Subject: BOOST Flex Plate, Bearing Shield & Isolator Replacement – **Revised to reflect change in 20" Upper Isolator and Nut, and further improvements to the Flex Plate mounting. Refer to TSBCL2010-21**

Models Affected: BOOST 28
BOOST 32 (05312K, 05313K)
Focus BOOST Rider (00344K)
Focus II BOOST L20 (05370A-S)
Focus II MID-SIZE BOOST 28 & 32

ECO#: A-05077, A-05249, A-05257, A-05349, A-05448, A-05476

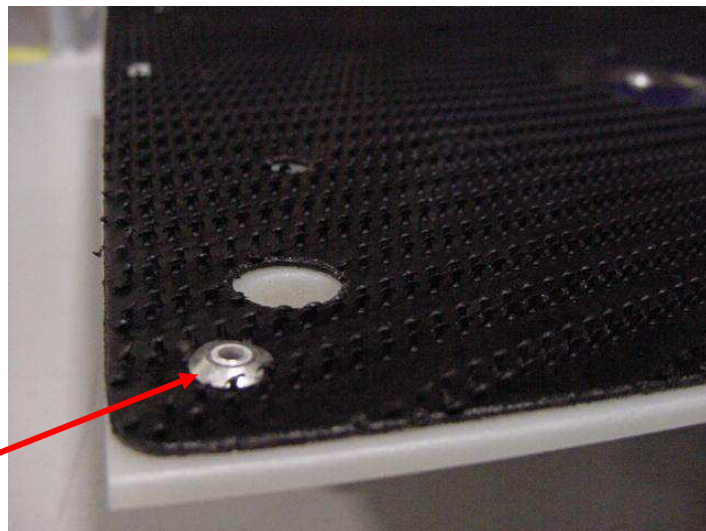
Thicker material allows use of rivets to improve connection between Pad Driver Material and Flex Plate.

Under certain conditions the adhesive on the new Flex Plate may break down and release along the edges, but this does not affect functionality. The additional rivet fastening maintains integrity and keeps the Pad Driver Material secured to the Flex Plate.

Figure 4 – Molded-in Hooks in New Driver Material

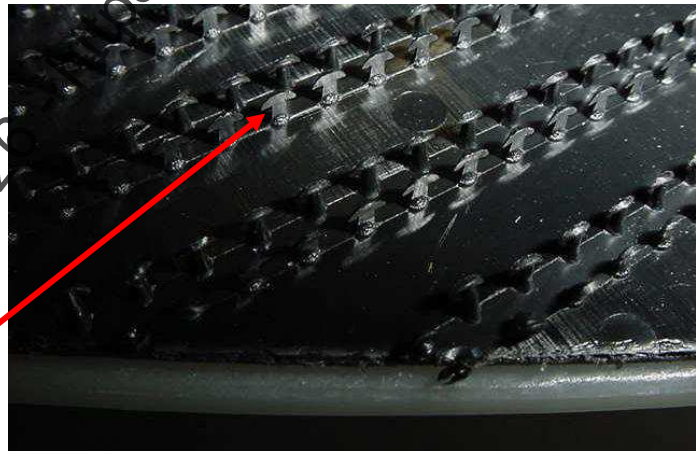
New Pad Driver Material has molded-in hooks to improve pad retention.

Figure 5 - New 32", 28" and 20" Flex Plates

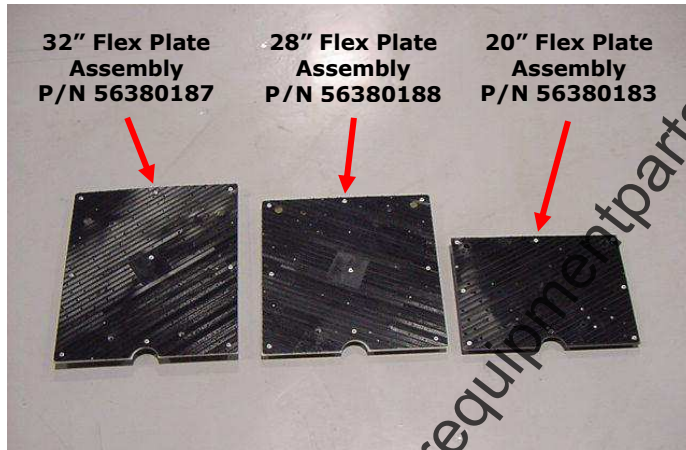
1. A new flex plate assembly was implemented with the following improvements:
 - a. Switched to a nylon pad driver material with "harpoon" style barbs (eliminated the fabric Velcro-type material)

- b. Mechanically securing the pad driver material via rivets
2. The bearing assembly was updated with the following changes:
 - a. Using an improved molded plastic bearing shield to deflect water away from the bearing. The new bearing shield uses a significantly more durable material and a tighter assembly fit for better retention and durability than the previous version.

Figure 8 - New Isolator

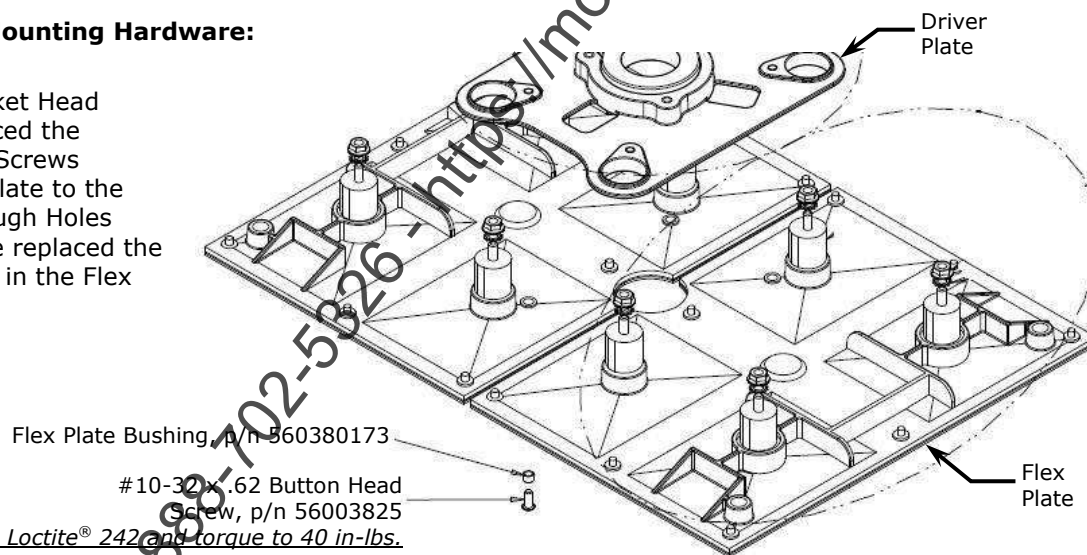
The new Isolators have stripes to aide in preventing over-tightening.

- Isolator 56380190 has a light blue stripe and replaces 53730A.
- Isolator 56380193 has a red stripe and replaces 54753B.
- Isolator 56380280 has a green stripe and replaces 56380223. Refer to TSBCL2010-21 for additional details.

New Isolators with visible vertical stripes to prevent over-tightening

Note: Isolators must not be over-tightened.
Maximum Torque: 8 to 10 ft-lbs.

Figure 9 - New Flex Plate Mounting Hardware

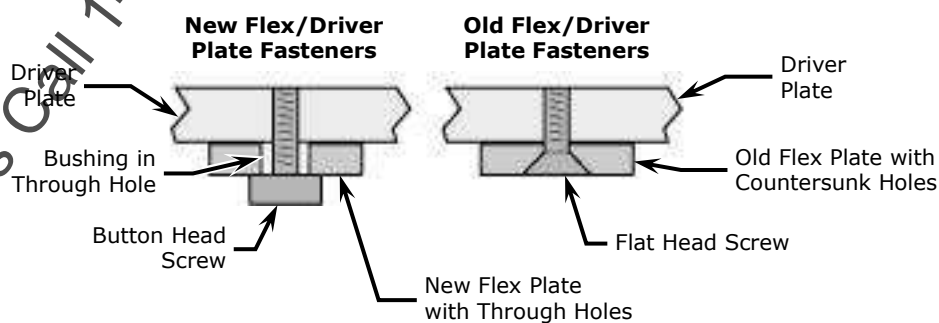
See Figure 9. Socket Head Screws have replaced the tapered Flat Head Screws securing the Flex Plate to the Driver Plate. Through Holes with Bushings have replaced the Countersunk Holes in the Flex Plate.

Note: Use Loctite® 242 and torque to 40 in-lbs.

Note: If you order a new Flex Plate, you'll need to order new fasteners:

- Flex Plate Bushing, p/n 560380173
- #10-32 x .62 Button Head Socket Screw, SS, p/n 56003825

Figure 19 – Scrub Deck Assembled to Mounting Bracket (20" Deck shown)

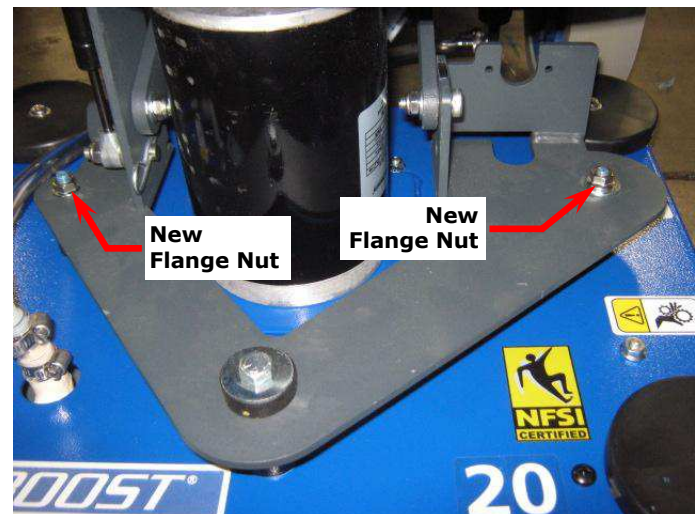
- d. Adjusted assembly process to reduced torque specification to prevent isolator twisting.
 - e. Locknut, p/n 920110, was replaced with a flange nut, p/n 81211A, to further reduce the potential of twisting the isolator during installation (see Figure 19). The upper isolator on the 20" machines was revised. Refer to TSBCL2010-21 for details.

IMPORTANT!
Torque nuts to 8-10 ft-lbs.
Look at the lines on the upper isolators and make sure they are not twisted, which indicates they are over tightened.
